Tasman Resource Management Plan

Plan Change 79 Deferred Zoning

Report prepared to fulfill the requirements of Section 42A of the
Resource Management Act 1991.

6.2.2 Plan Topic Number: Rezone Record of Title 856882 from Rural deferred Mixed Business to Mixed Business

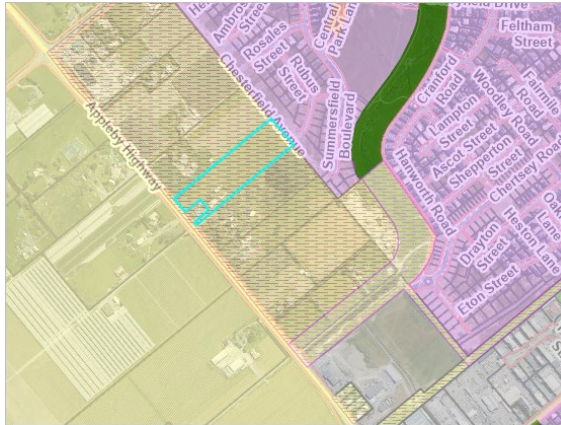
Appleby 88 Ltd Submission Nos: 4227.1; 4227.2 and 4227.10 request that land owned by the submitter within RW5 (RT 856882 – 0 Appleby Highway) is upzoned from Rural 1 deferred Mixed Business to Mixed Business because the property is serviceable. The location of the site within RW5 is shown below.
